PRODUCT CHANGE NOTIFICATION (PCN)

AB973
DSUB CABLE

CHANGE NOTIFICATION:	PCN 20221216_AB973
DESCRIPTION OF CHANGES:	CHANGE OF DATA SHEET CHANGE OF PRODUCT DESIGN New Draw.-No. ASS_7065_CArev02
REASON FOR CHANGE:	CHANGE OF PRODUCT DIMENSIONS, TOLERANCES AND/OR PROPERTIES CHANGE OF MATERIAL PARAMETERS OR PROPERTIES
KEY CHARACTERISTICS OF CHANGE:	Details see page 3&4
PRODUCTS AFFECTED:	AB973
DATE OF CHANGE AND IMPLEMENTATION:	CHANGE: WEEK 52 / YEAR 2022 IMPLEMENTATION: 16/12/2022
RESPONSE:	RESPONSE TO THIS NOTIFICATION IS REQUIRED

AB973 OLD VERSION

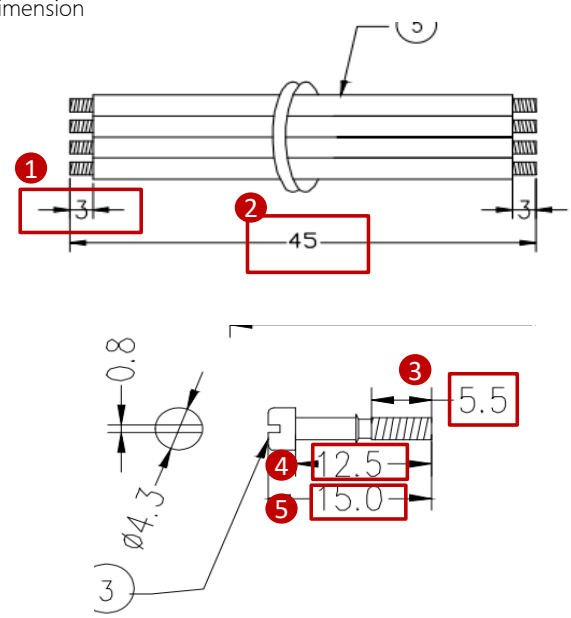
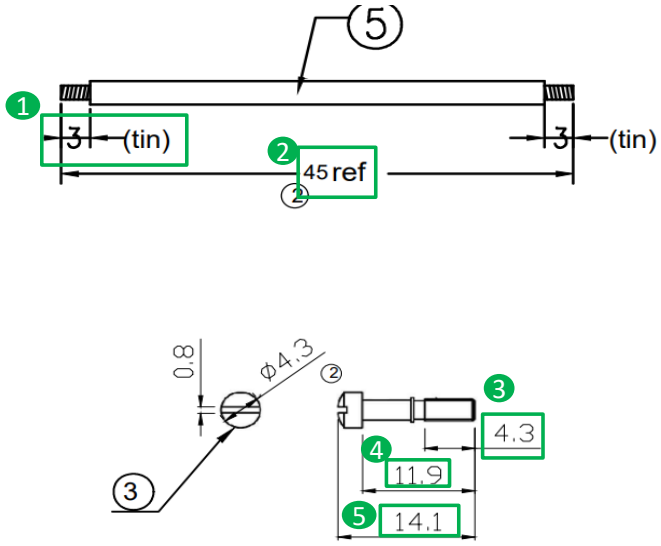
5	UL1007 26AWG INSULATOR WIRE, LENGIH	25
4	PCB: SAK-7	1
	ELECTRO-PLATED HOOD	1SET
3	SCREW 4*12.5mm, #4-40,WITH PAD,ASSEMBLY TYPE	4
2	DB25 MALE, GOLD FLASH ON CONTACTS, BLUE INSULATOR	1
1	DB25 MALE, GOLD FLASH ON CONTACTS, BLUE INSULATOR	1
No.	DFSCRIPTION	Q'TY

5	UL1061 26AWG INSULATOR WIRE,	25MIN	PCS
4	PCB	1	PCS
	PVC HOOD	1	SET
3	SCREW ,2.4*11.9mm, #4-40,WITH PAD,ASSEMBLY TYPE	4	PCS
2	DB25 MALE, GOLD FLASH ON CONTACTS, WHITE INSULATOR	1	PCS
1	DB25 MALE, GOLD FLASH ON CONTACTS, WHITE INSULATOR	1	PCS
NO.	DESCRIPTION	QTY	UNIT

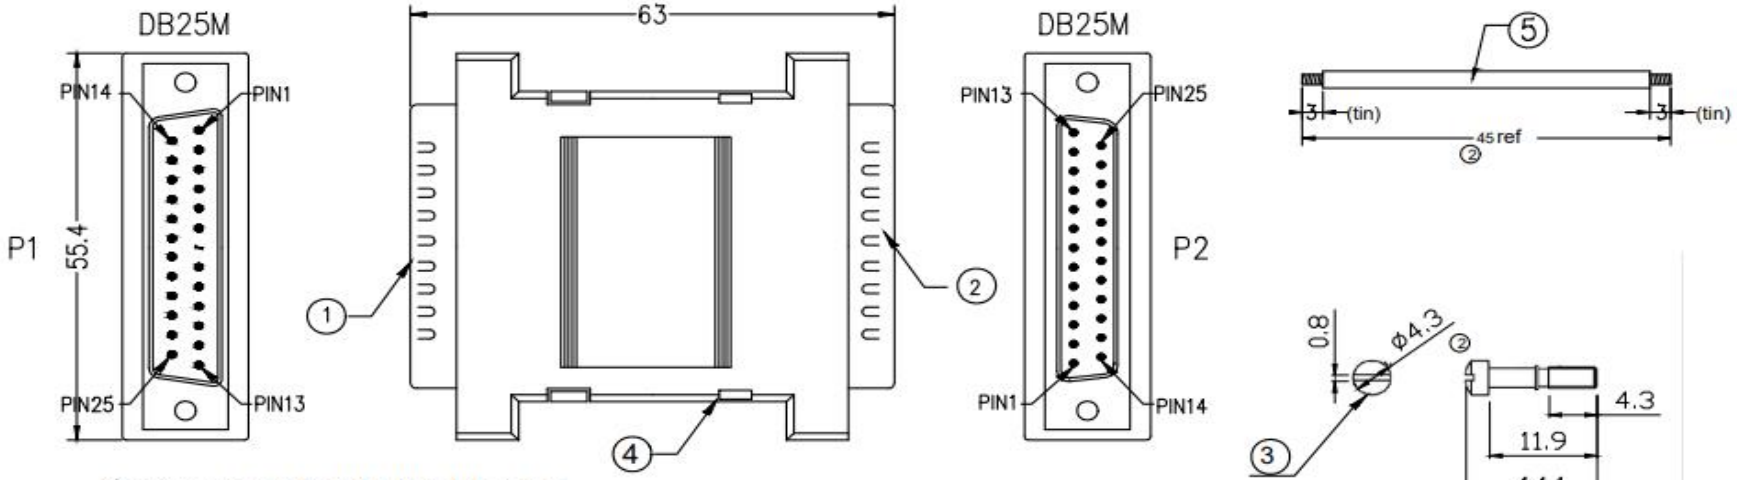
② Components inside the PE bag:

NO.	DESCRIPTION	QTY	UNIT
5	UL1061 26AWG INSULATOR WIRE,	25MIN	PCS
4	PCB	1	PCS
	PVC HOOD	1	SET
3	SCREW ,2.4*11.9mm, #4-40,WITH PAD,ASSEMBLY TYPE	4	PCS
2	DB25 MALE, GOLD FLASH ON CONTACTS, WHITE INSULATOR	1	PCS
1	DB25 MALE, GOLD FLASH ON CONTACTS, WHITE INSULATOR	1	PCS
